STAFF RECOMMENDATION
2809 27th Avenue South
February 20, 2019

Application: New Construction—Infill and Outbuilding
District: Hillsboro-West End Neighborhood Conservation Zoning Overlay
Council District: 18
Map and Parcel Number: 11703015300
Applicant: Manuel Zeitlin
Project Lead: Melissa Baldock, melissa.baldock@nashville.gov

Description of Project: Application is to construct infill and an outbuilding on a vacant lot.

SITE PLAN **A1**

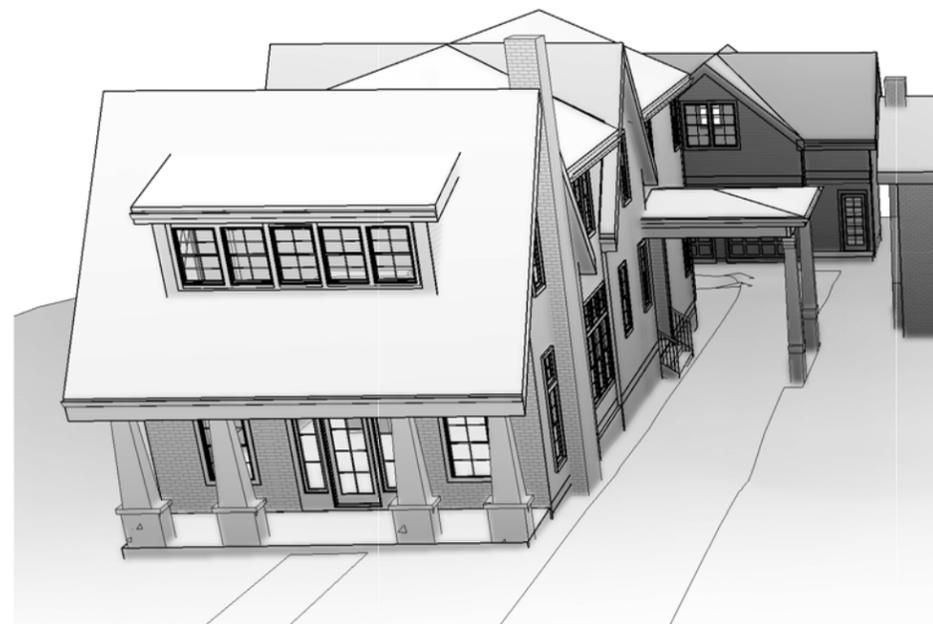
Setback & Rhythm of Spacing: The infill's front setback will be approximately thirty-five feet (35') to the front porch and forty three feet (43') to the house's front wall. This is approximately the same front setback as the infill house next door at 2813 27th Avenue South, although staff recommends inspection in the field to ensure the compatibility of the front setback. Note that the historic house to the right at 2807 27th Avenue South has an unusually deep front setback, setting the house at the back of the lot.

The infill meets all base zoning setbacks. It will be five feet (5') from the left side property line. The bulk of its right side property line will be approximately eighteen feet (18') from the side property line, but the porte cochere will extend to be five feet (5') from this right side property line. It will be approximately eighty-five feet (85') from the rear property line. Staff finds that the infill's setback and rhythm of spacing to meet Section II.B.1.c. of the design guidelines.

Orientation: The infill will be oriented towards 27th Avenue South, which is appropriate. It includes an eight foot (8') deep, full-width front porch. A walkway will be added from the street to the front porch. Vehicular access will be via a ten foot (10') wide driveway to the right of the house. The driveway extends all the way to the rear of the property to a

Appurtenances & Utilities: A new driveway will be added on the right side of the property, as the site lacks alley access. The driveway will be ten feet (10’) wide, and staff finds this to be appropriate. The location of the HVAC and other utilities was not noted. Staff recommends that the HVAC be located on the rear façade, or on a side façade beyond the midpoint of the house. With the staff’s approval of the HVAC location, staff finds that the proposed appurtenances and utilities meet Section II.B.1. i. of the design guidelines.

1. The finished floor height shall be consistent with the finished floor heights of the adjacent historic houses, to be verified by MHZC staff in the field;
2. Staff approve the front setback in the field after staking;
3. Staff approve the final details, dimensions and materials of windows and doors prior to purchase and installation;
4. Staff approve brick sample;
5. Staff approve the material of the front porch floor and steps;
6. Staff approve the roof shingle color, material, and texture;
7. A walkway be included from the street to the front porch, and staff approve the walkway material; and
8. The HVAC shall be located behind the house or on either side, beyond the mid-point of the house.

2809 27TH AVE S
HISTORIC SUBMITTAL
 ELEVATIONS
 2-04-19 1758
A2
 MANUEL ZEITLIN ARCHITECTS
 TEL 615256.2880
 FAX 615256.4839
 516 HAGAN ST, SUITE 100 NASHVILLE, TN 37203

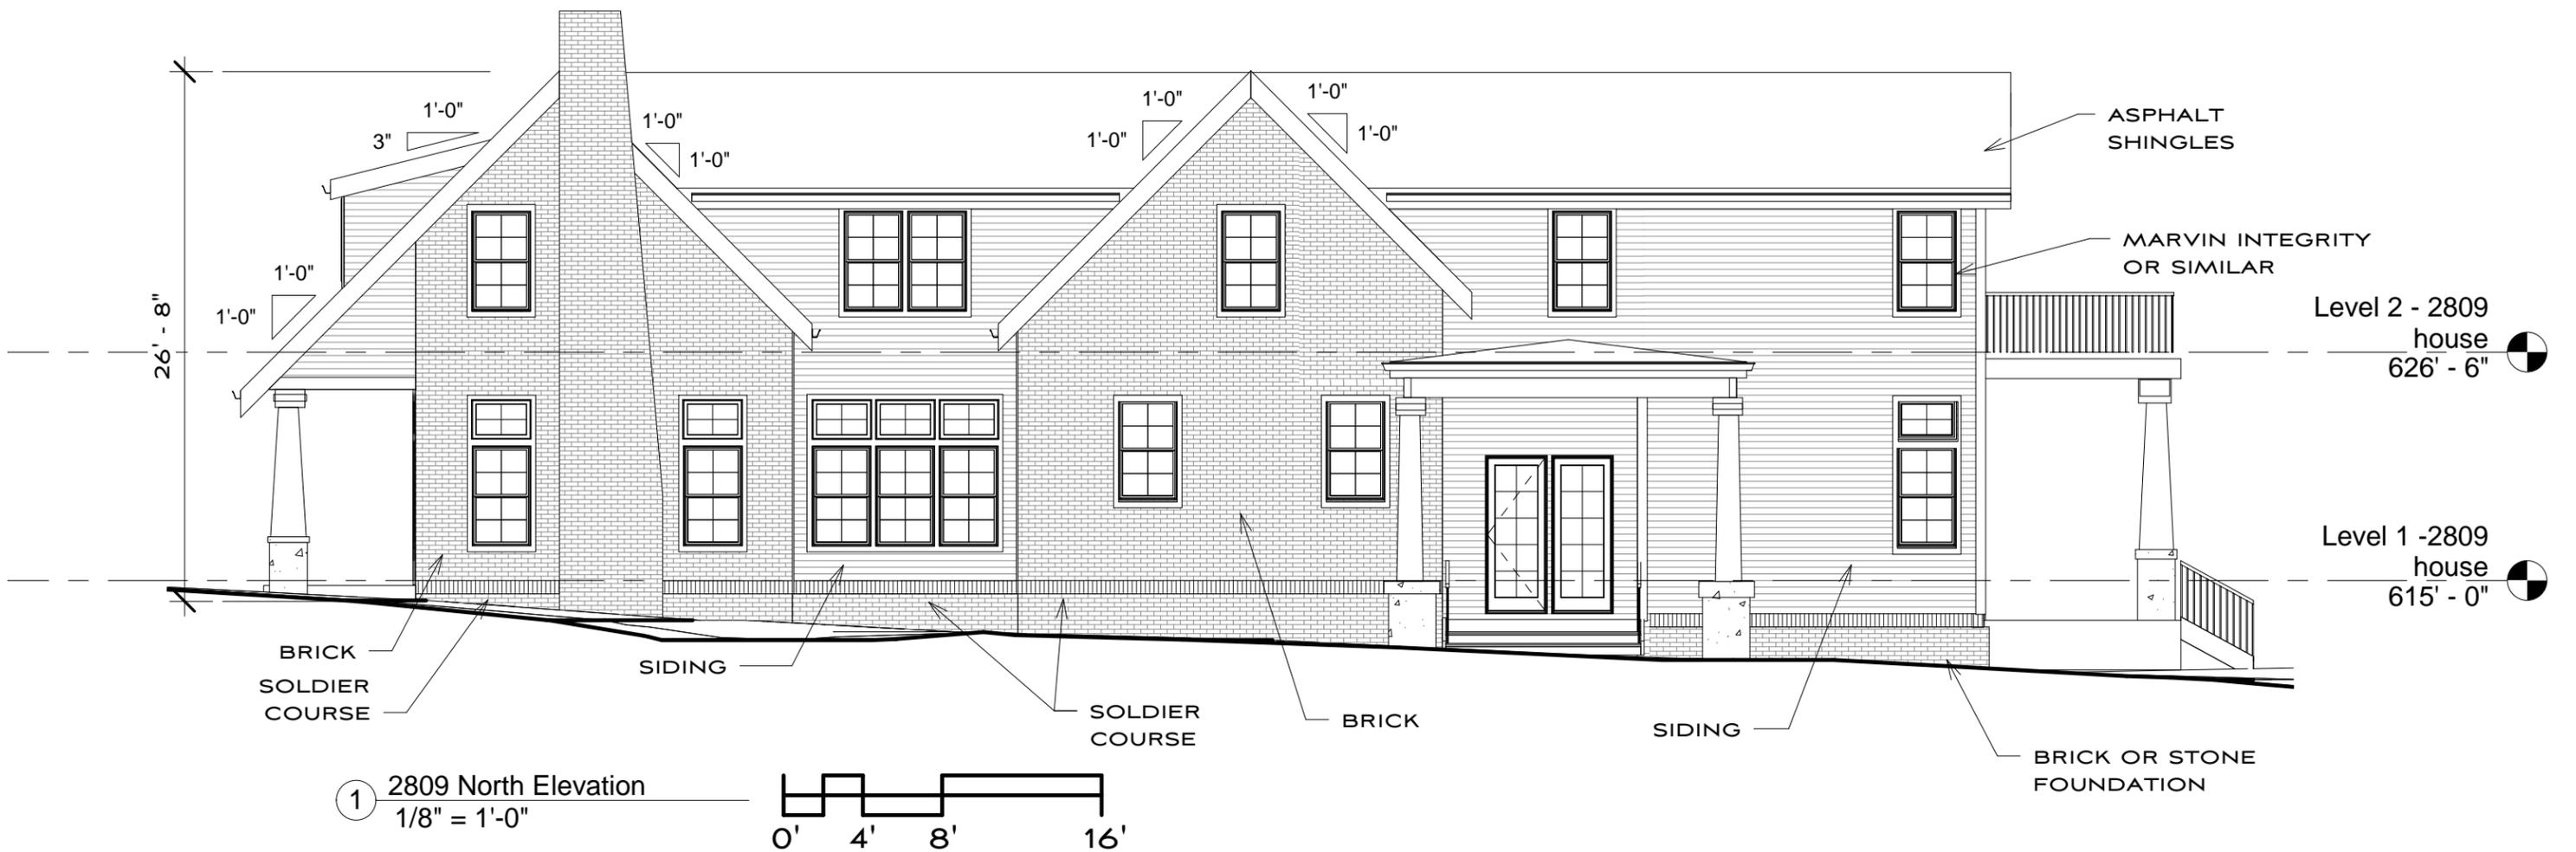
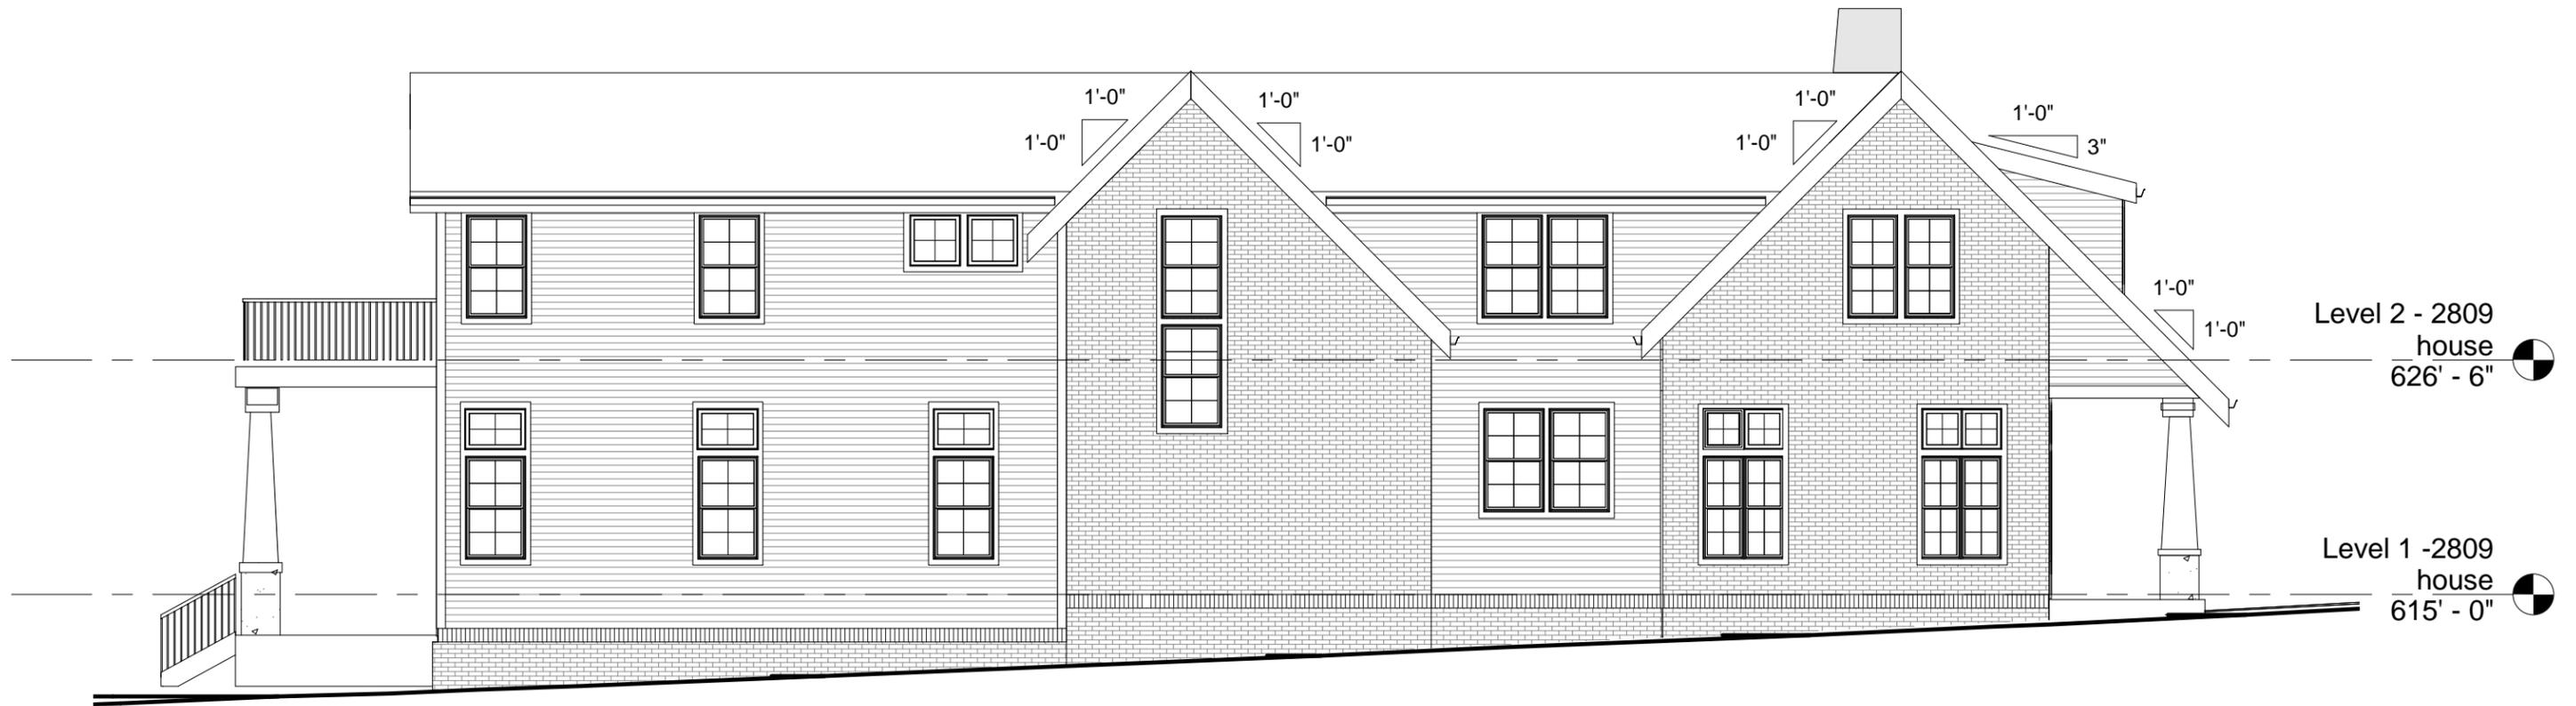
Height & Scale: The proposed infill is one-and-a-half-stories in height at the front. It has an eave height of approximately nine feet (9') at the front from the foundation line and a ridge height of approximately twenty-six feet, eight inches (26' 8"). Staff finds that the infill's height meets the historic context where houses range in height from nineteen and twenty-eight feet (19'-28') in height.

The site slopes slightly towards the back so that at the rear, the house is two-stories in form, even though its height is consistent with the front of the house. Staff finds this to be appropriate as the historic house to its right is two stories in form. The foundation height is shown as minimal at the front and gets taller further back on the site because of the slope. Staff recommends approval of the foundation height and first floor framing height in the field to ensure that the foundation and floor heights are compatible with the immediate historic context.

Roof form: The house's primary roof form is a side gable with a 12/12 slope. The front dormer will be a shed dormer with a 3/12 slope. The side facades incorporate more gable forms. The porte cochere will have a low-sloped hipped roof, which is appropriate for this type of architectural feature. Staff finds that the proposed roof forms meet Section II.B.1.e. of the design guidelines.

Proportion and Rhythm of Openings: The windows on the proposed infill are largely twice as tall as they are wide, thereby meeting the historic proportions of openings. The left elevation, ground floor, includes a wall space of approximately eighteen feet (18’) without a window or door opening. Staff finds this to be appropriate because it is located approximately thirty feet (30’) back from the front wall of the house and will not be highly visible from the street. Staff finds the project’s proportion and rhythm of openings to meet Section II.B.1.g. of the design guidelines.

2809 27TH AVE S
HISTORIC SUBMITTAL
ELEVATIONS
2-04-19 1758

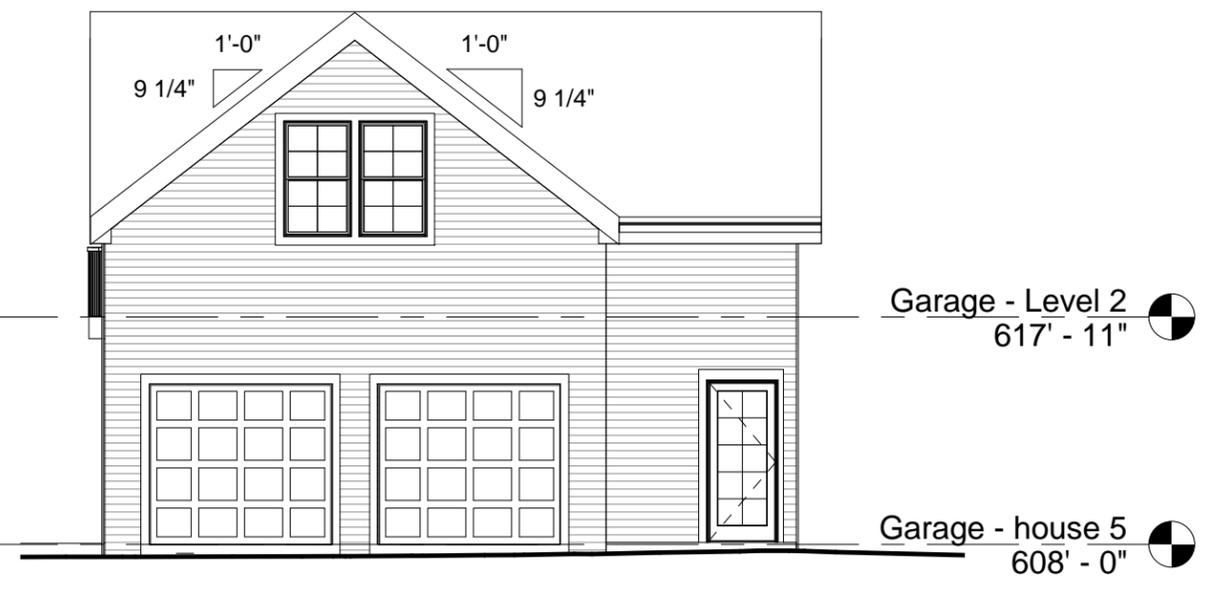
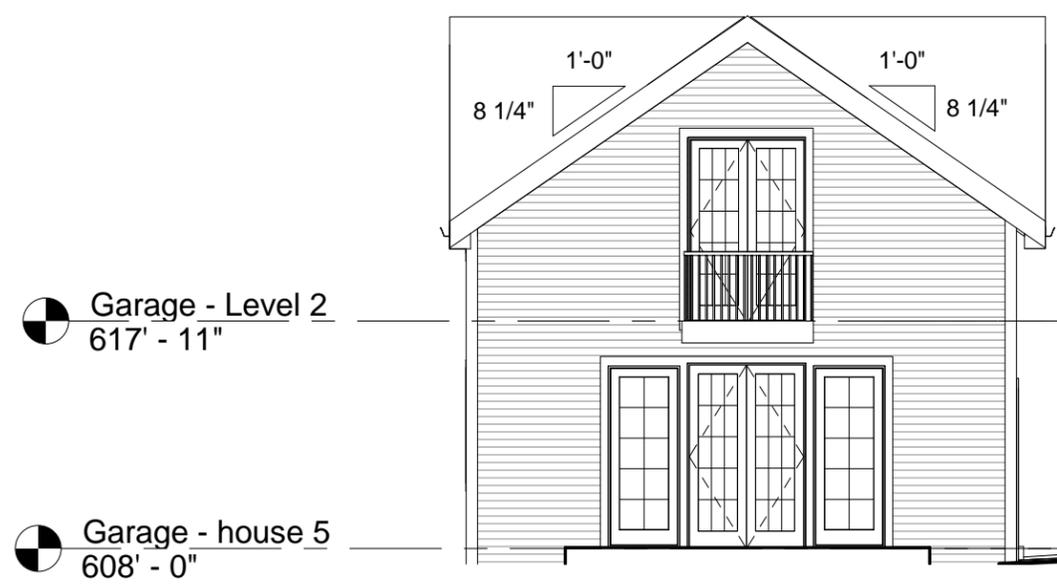
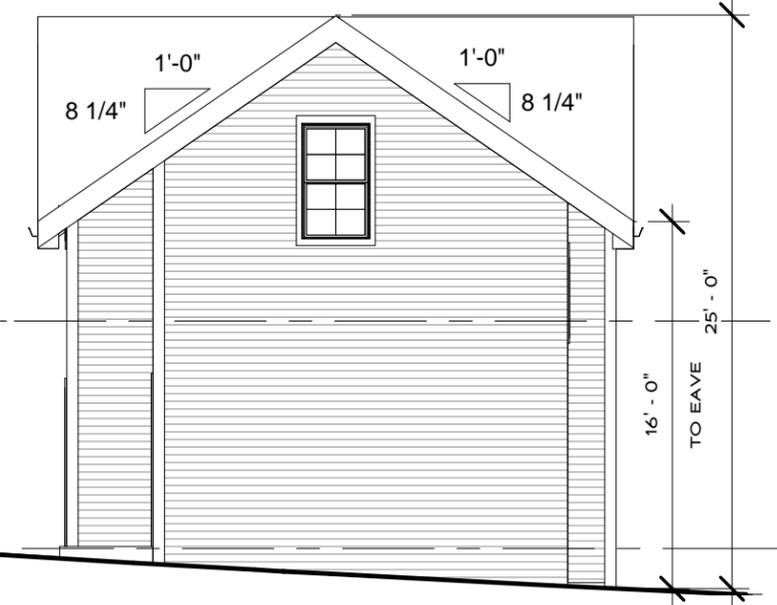
Design Standards: The outbuilding is two stories, which staff finds to be appropriate in this instance because the eave height of the outbuilding is the same as the average four eave heights of the infill, as measured from finished floor. The outbuilding has a simple design that is appropriate for an accessory structure. Staff finds that the proposed design meets Section II.B.h.1 of the design guidelines.
